**Economic Commission for Europe****Inland Transport Committee****Working Party on Customs Questions affecting  
Transport****Informal Ad hoc Expert Group on Conceptual and  
Technical aspects of Computerization of the TIR Procedure****Nineteenth session**

Belgrade, 13–14 September 2011

**Reference Model of the TIR procedure:****eTIR Reference Model, version 3.0****Amendment proposal on the introduction of international  
declaration mechanisms****Note by the secretariat****I. Mandate**

Figure 2.1

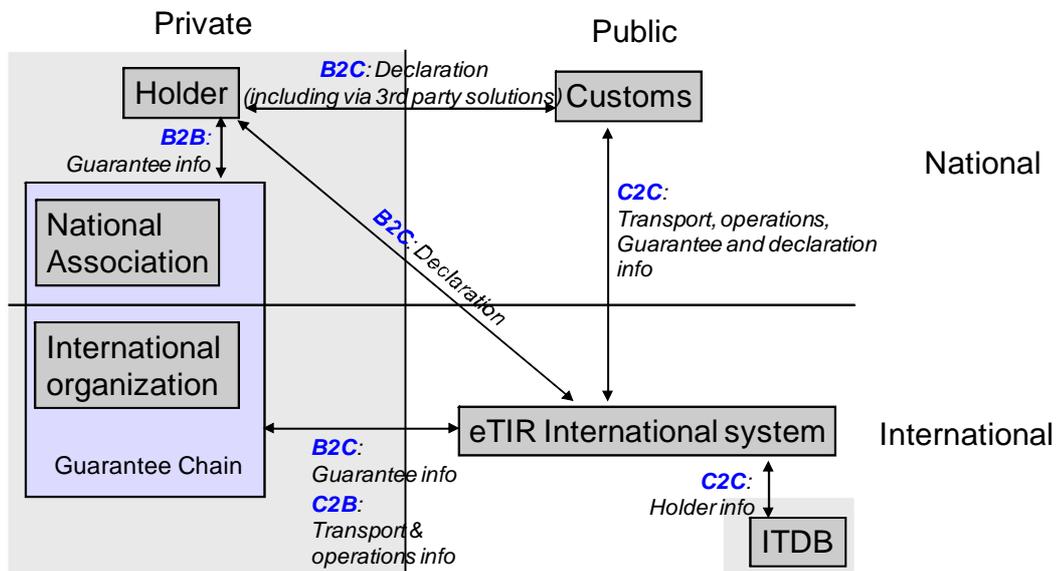
The holder submits the advance cargo information by electronic means to the Customs office of departure, making reference to a guarantee issued by a Guarantee Chain, using authentication mechanisms. The declaration shall be submitted prior to the presentation of the goods at the Customs office of departure. **Alternatively, the holder can make use of**

**declaration mechanisms provided by either the eTIR international system or the private sector.**<sup>5</sup>

Figure 2.2  
**Customs management of guarantees use case diagram**

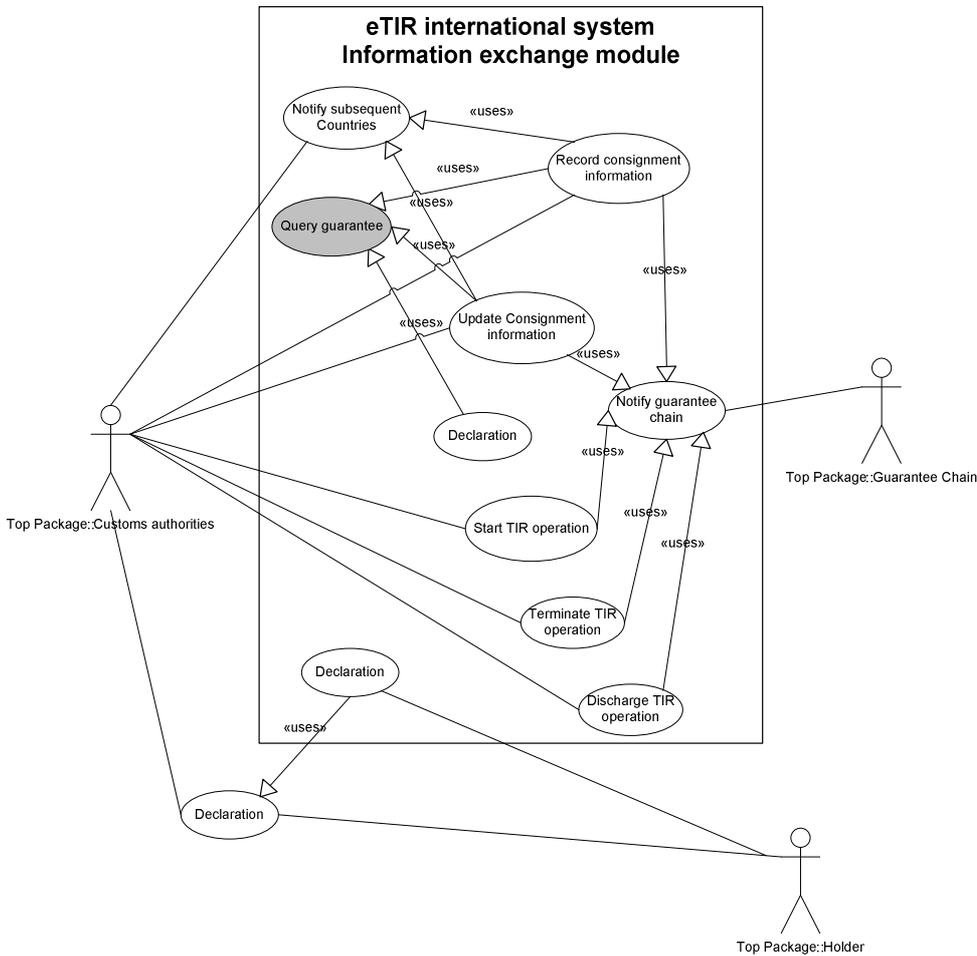
Web services implemented at the central platform allow authorized computer systems to interact securely with the eTIR international system. The web services provide, in a standard format, the functions which allow querying and updating the central database, **as well as the centralized submission of advance cargo information.**

Figure 2.17  
**Advance cargo information activity diagram**

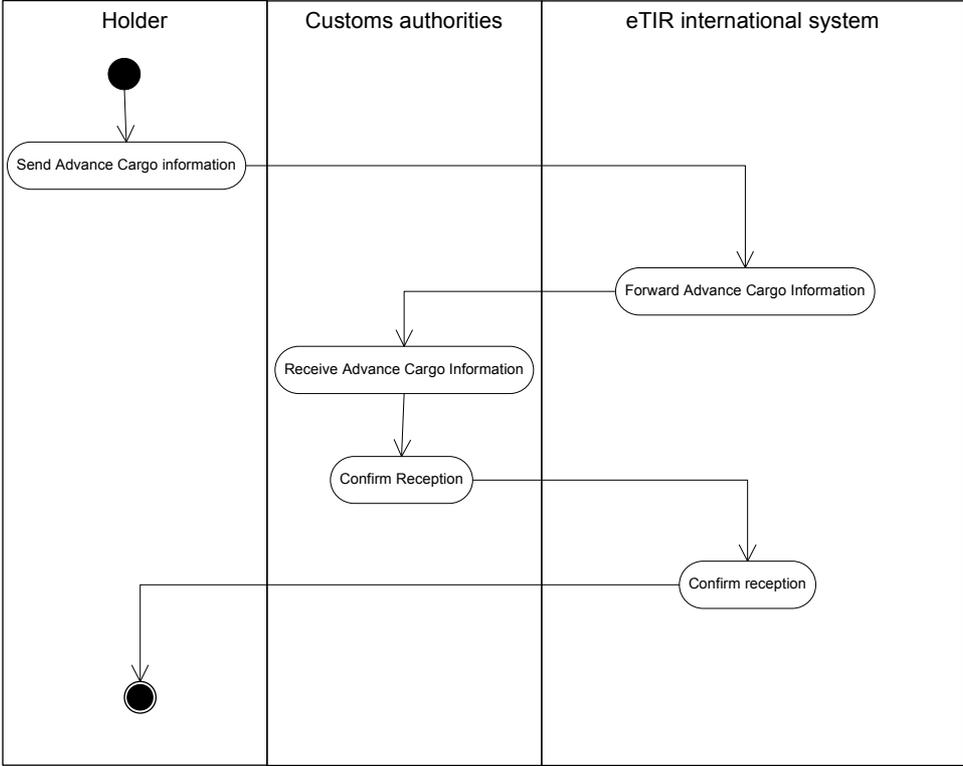
<b><u>Name</u></b>	<b><u>Declaration use case</u></b>
<b><u>Description</u></b>	<b><u>The holder transmits an advance cargo declaration to the eTIR international system that then forwards it to the Customs authorities of the country of first Customs office of departure.</u></b>
<b><u>Actors</u></b>	<b><u>Holder, Customs authorities</u></b>
<b><u>Performance Goals</u></b>	
<b><u>Preconditions</u></b>	<b><u>The holder is registered in the Authentication database (see 2.1.3.2.10)</u></b>
<b><u>Postconditions</u></b>	<b><u>:</u></b>
<b><u>Scenario</u></b>	<b><u>:</u></b>
<b><u>Alternative Scenario</u></b>	<b><u>Fallback scenario</u></b> <b><u>In case transmission by means of web services is not available, the holder can use the eTIR website or other available declaration mechanisms.</u></b>
<b><u>Special requirements</u></b>	<b><u>:</u></b>
<b><u>Extension Points</u></b>	<b><u>:</u></b>
<b><u>Requirements Covered</u></b>	<b><u>:</u></b>

**New Chapter 2.3.2.17. Advance cargo information activity diagram**

Figure 3.15:  
**Advance cargo information sequence diagram**

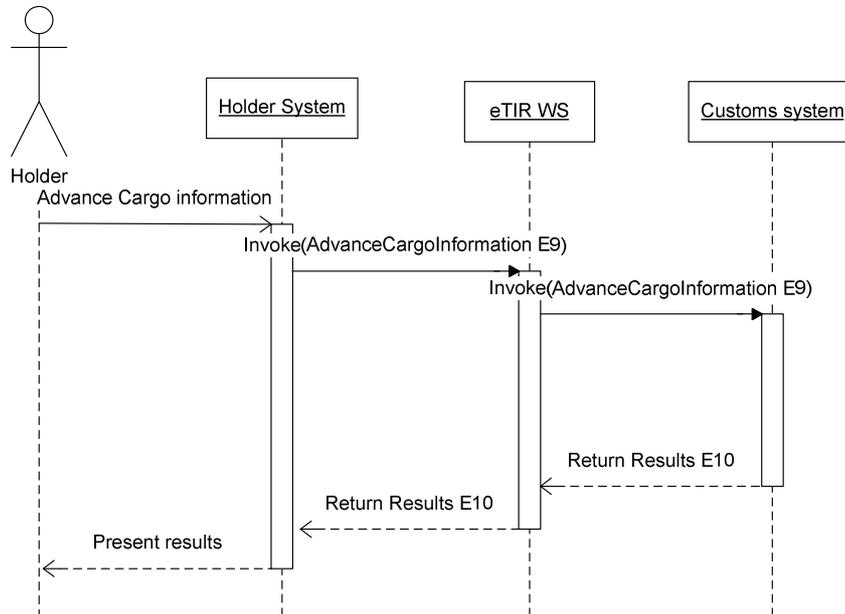
**New Chapter 3.1.1.2.8 Advance cargo information**
